Contract No. 2435

**Replacement of Victoria Ave East Bridges over Pilot Butte Creek
and Victoria Ave Widening**

ADDENDUM # 1

May 13, 2015

DETAIL PLAN - WEST

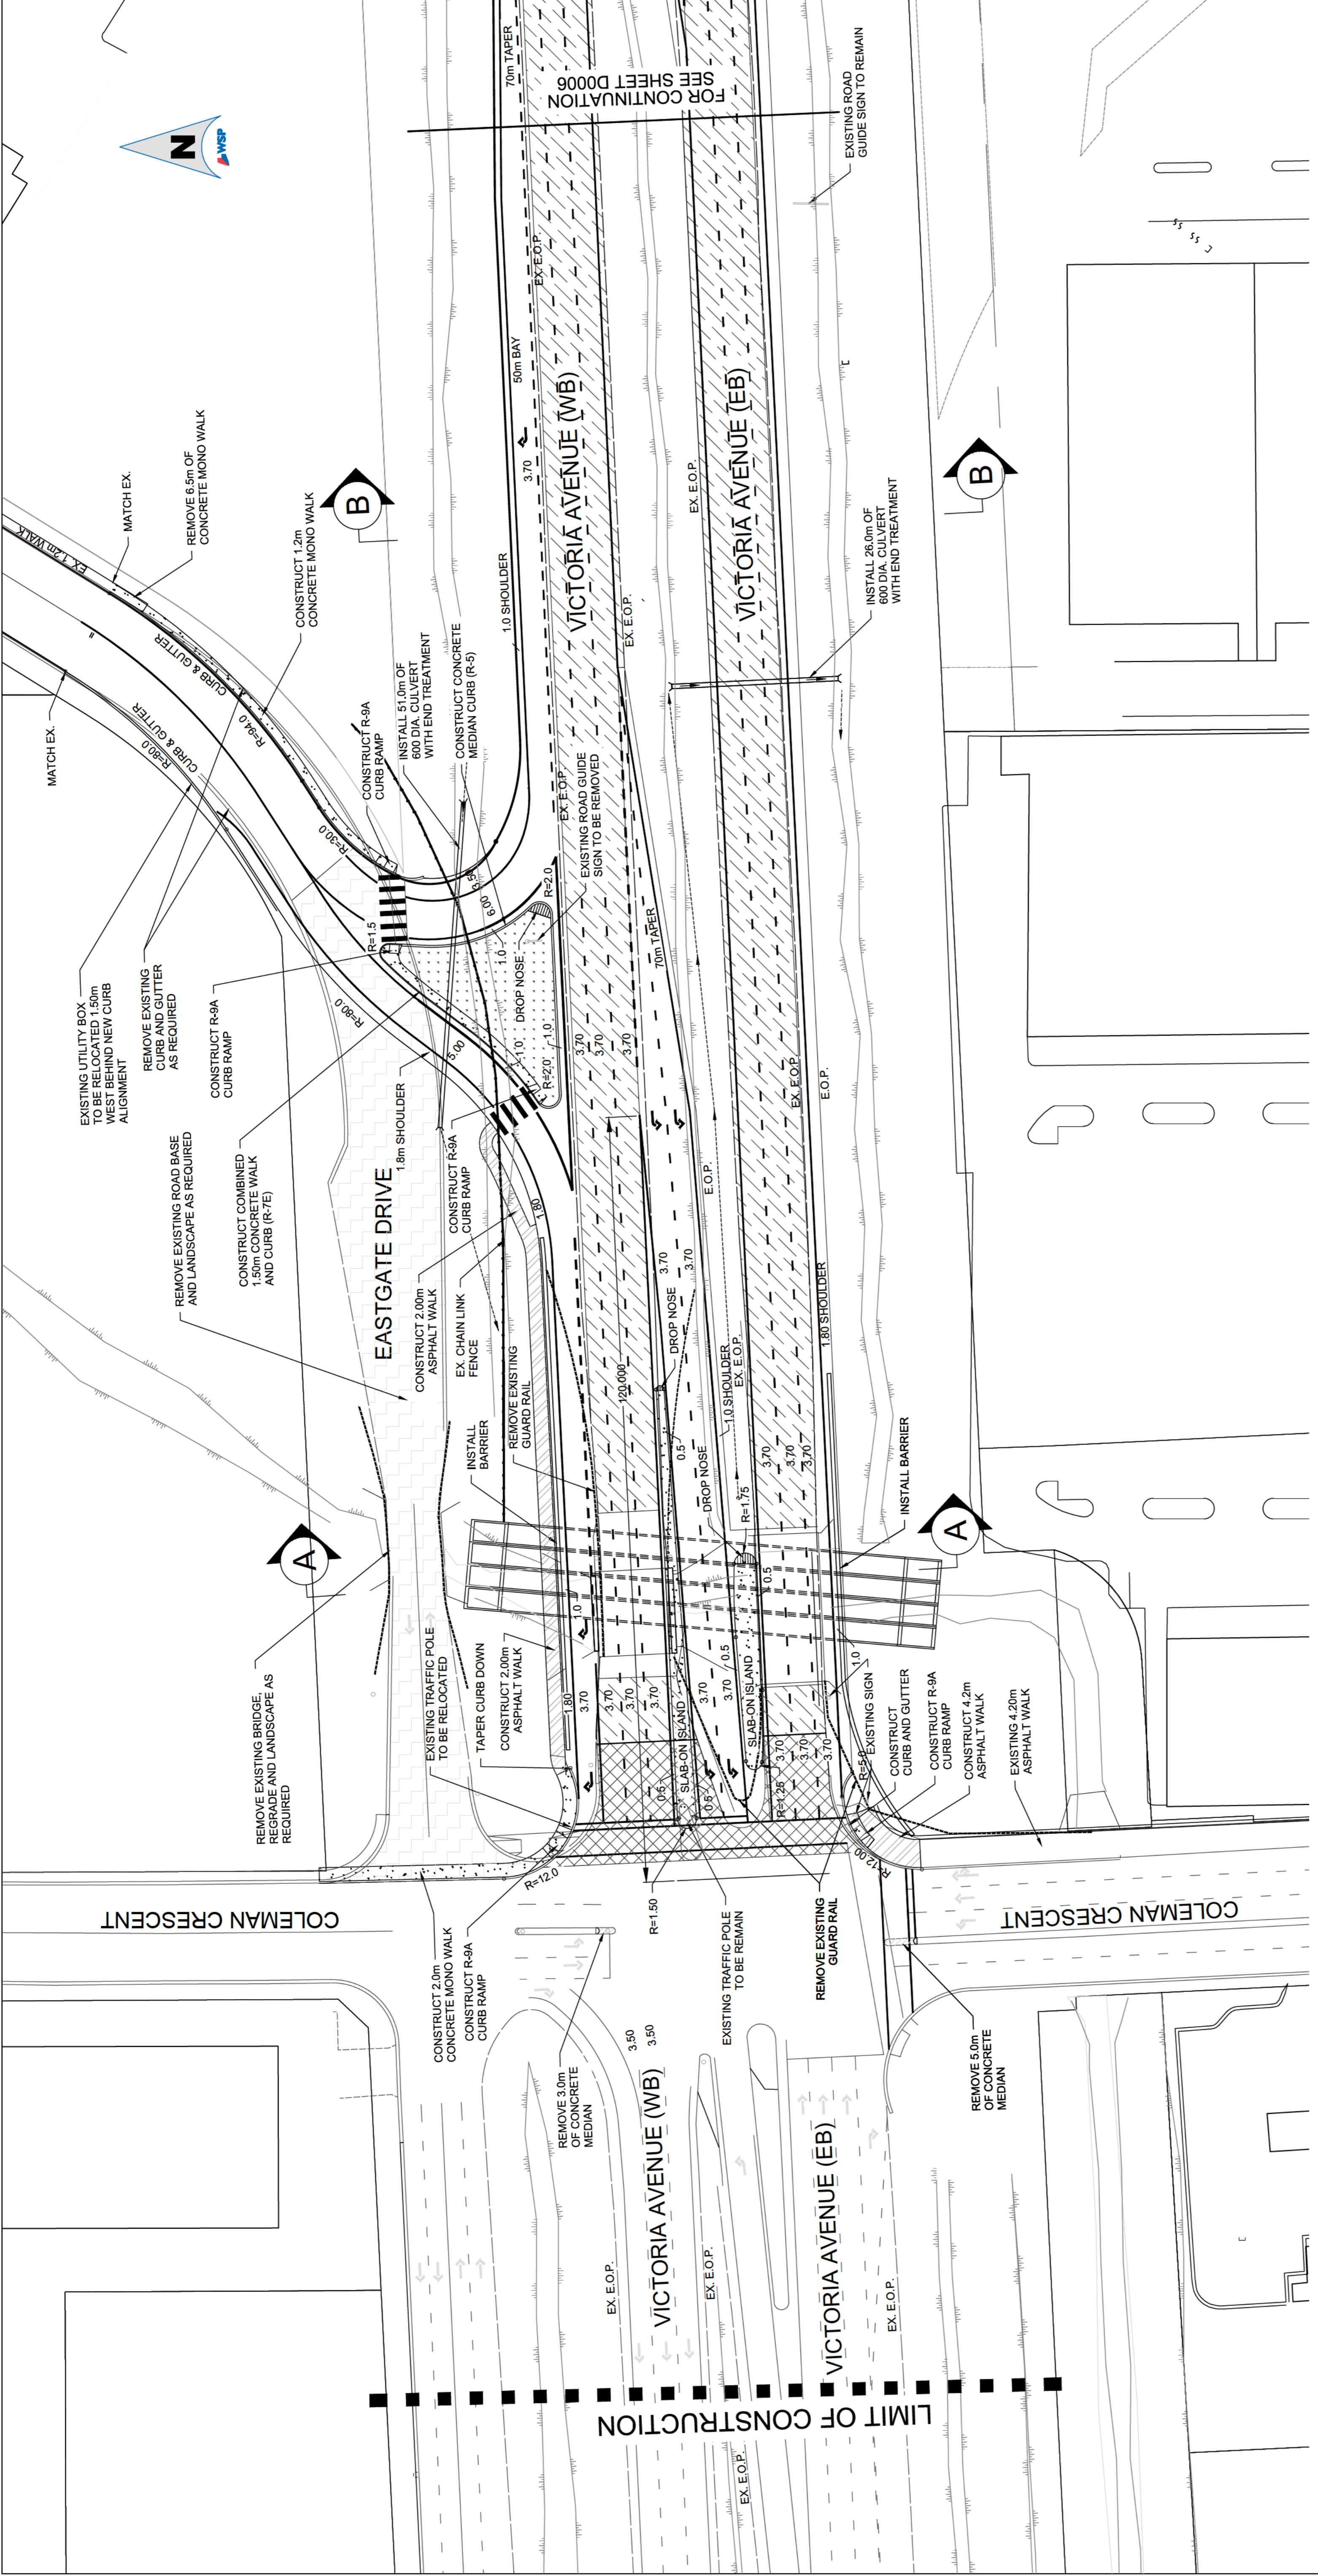
6. DRAWING D-0005 – DETAIL PLAN - WEST

- a) This drawing has been revised and re-issued as Rev. C. Notes were added regarding the curb and walk required for the Right In – Right Out median.
